ADDENDUM NO. 1
TO CONTRACT DOCUMENT PLANS SPECIFICATIONS

**PROJECT: MWA METRO PARK WEST LANDFILL
P-67 CELL E LINER, LEACHATE LAGOON, AND SED POND**
TO: PROSPECTIVE BIDDERS AND OTHER INTERESTED PARTIES

Project: P-67 MPW Cell E Liner, Leachate Lagoon, and Sed Pond

EXISTING CONDITIONS AND
OVERALL DEVELOPMENT PLAN

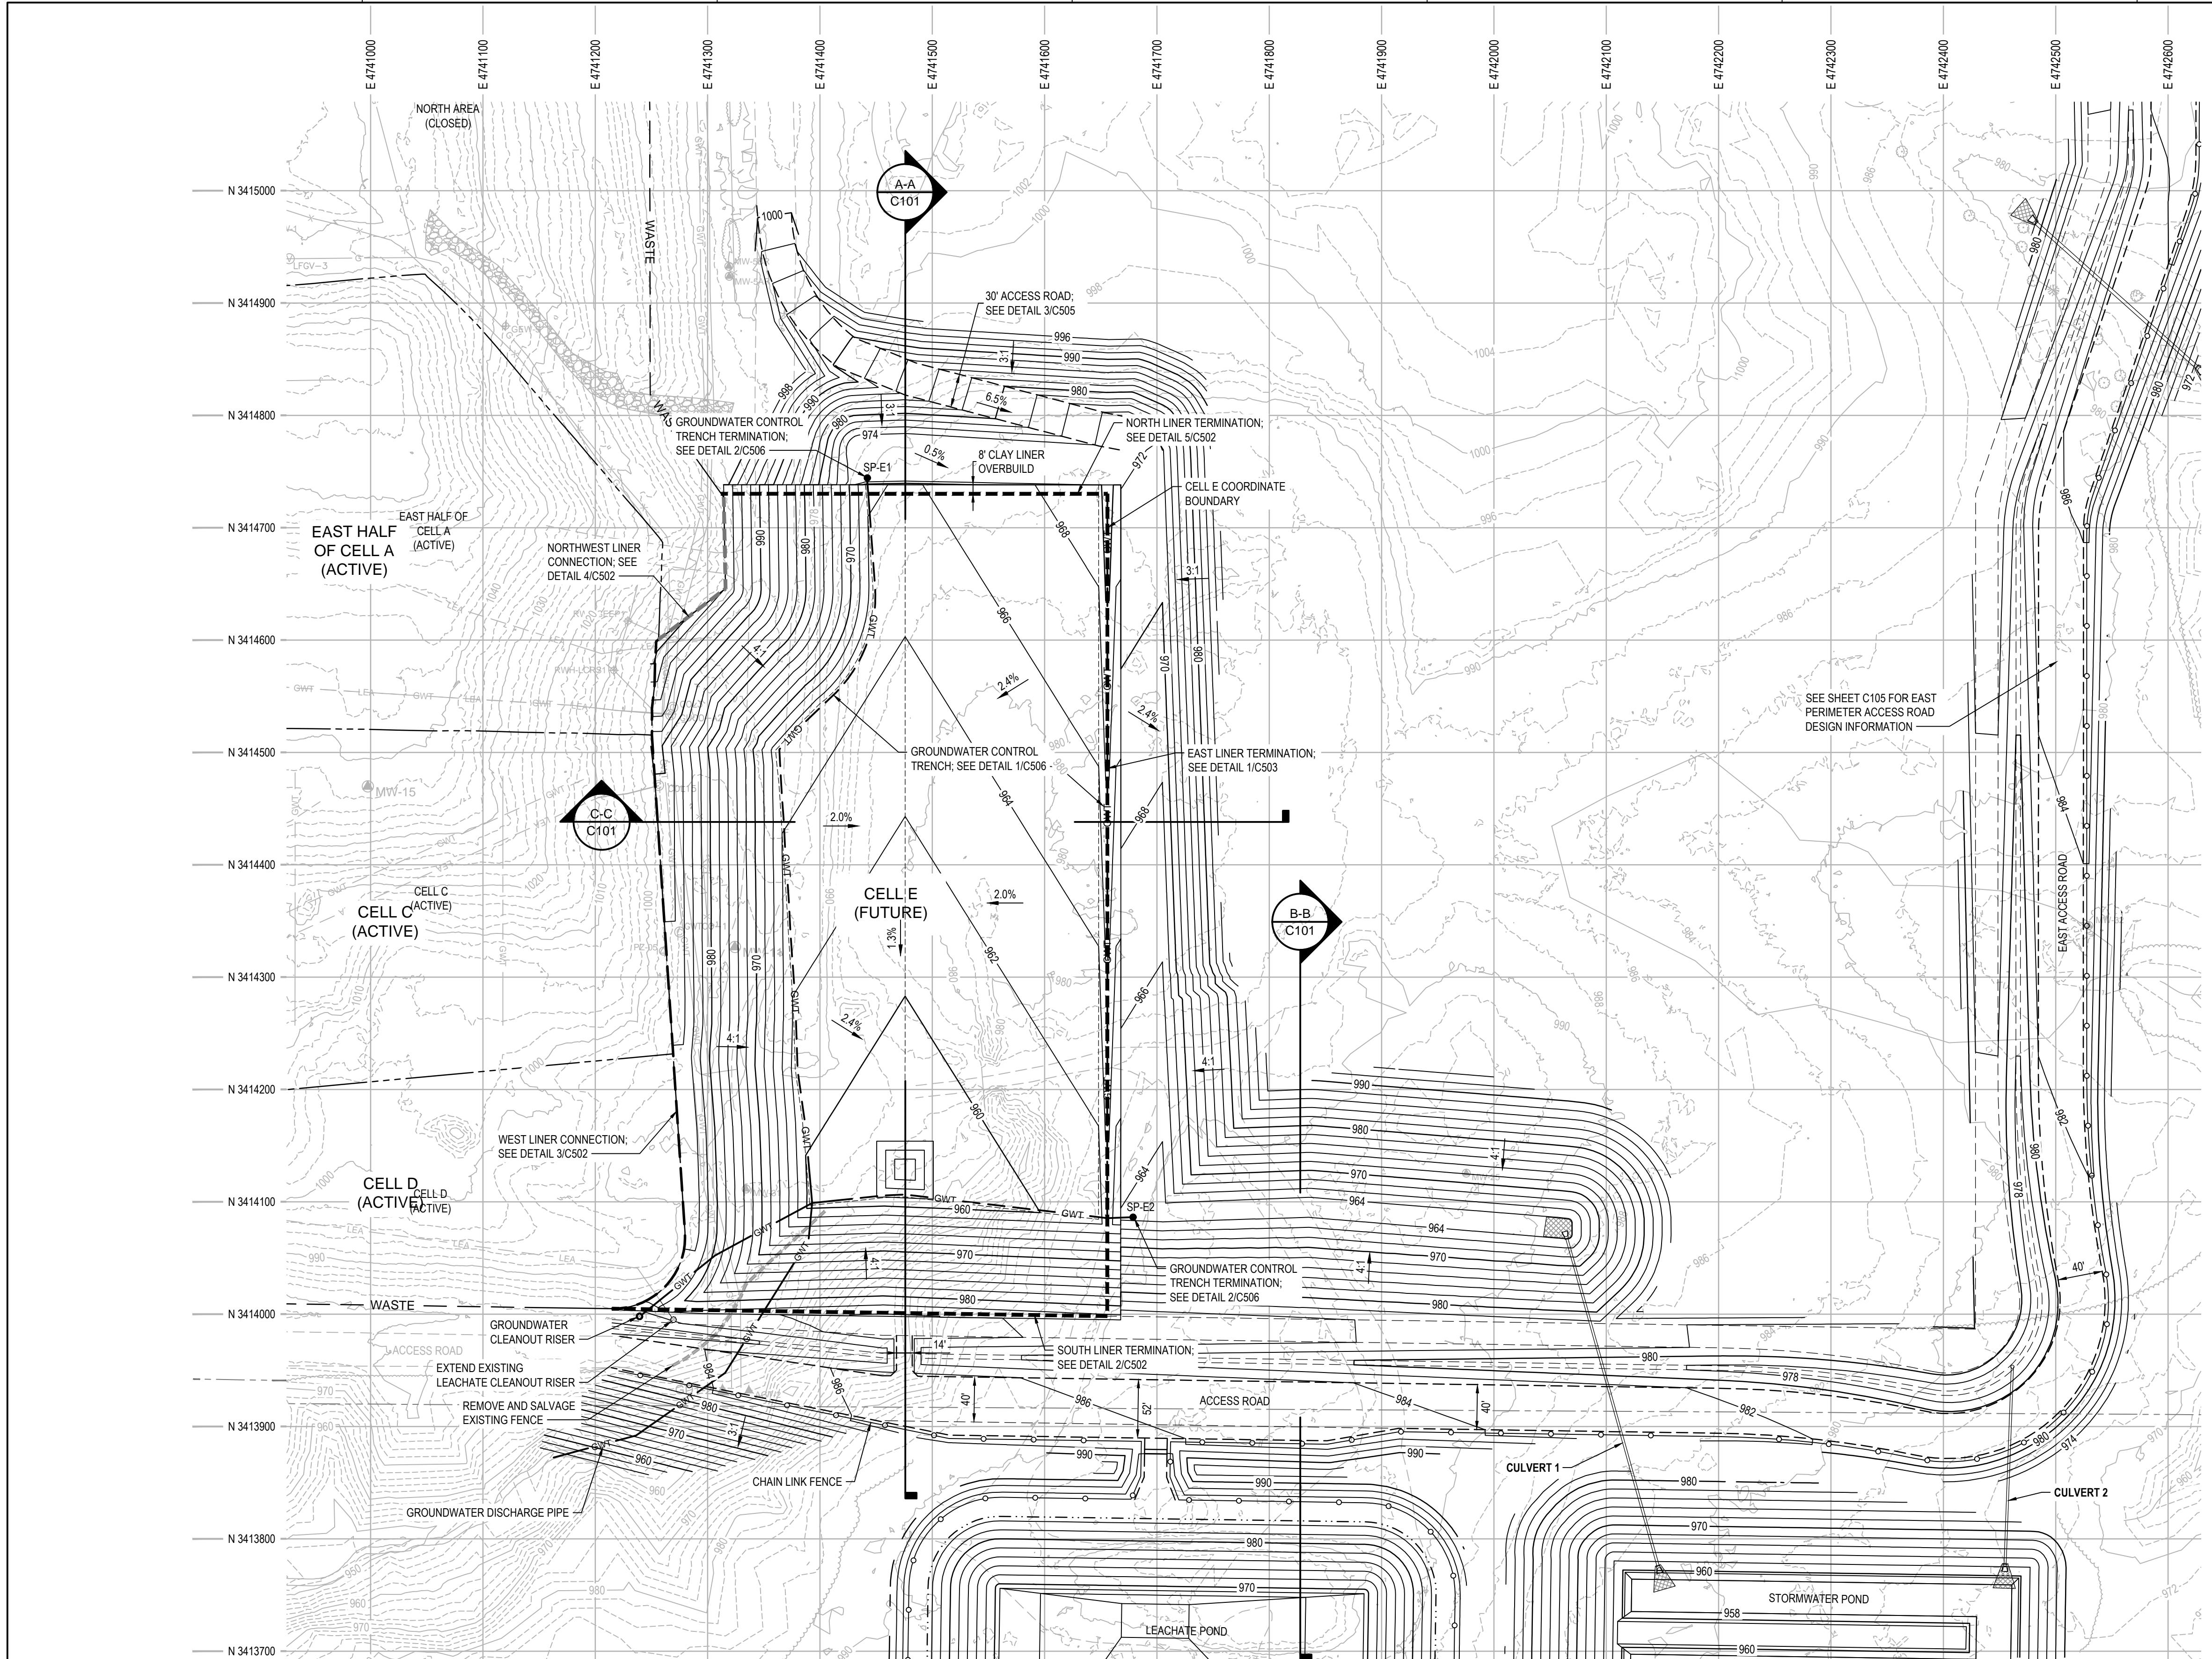
- a. G002: Updated extents of project.
- b. C105: ADDED for perimeter road and z-wall.
- c. C106: ADDED for Northwest perimeter road over final cover area.
- d. C509: Updated for perimeter road details.
- e. C510: ADDED for z-wall details.
